MASTER BOAT BUILDERS, INC.
P.O. Box 702 Boyou LaBatre, AL 36509
150'-0" x 36'-0" x 12'-0"
OSV

PILOT HOUSE STRUCTURE

Sheet: 1 of 1 Drawing Number: S-6 Rev: 1

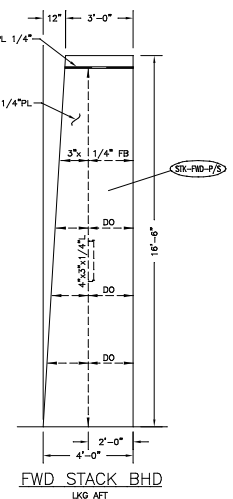
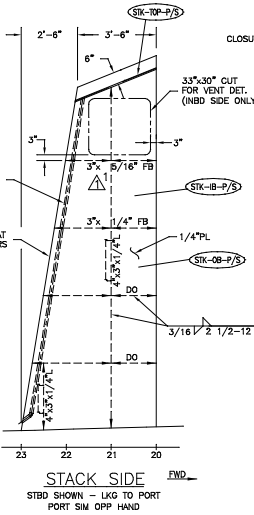
REV.	DESCRIPTION	DATE	BY
1	REVISED STIFF ABOVE WINDOW CUTS FROM FB TO 4"x3/8"x1/4". REVISED SIZE OF FB BELOW VENT CUTOFF ON STACK.	1-9-03	CB
2	ADJ CHANGES PER ABS LTR DTD SEPT 12 2002.		
3	MOVED STIFFENERS ON PILOT HOUSE TOP TO LINE UP WITH MAST.		
4	CORRECTED LOFTED PIECE MARKS THROUGHOUT.
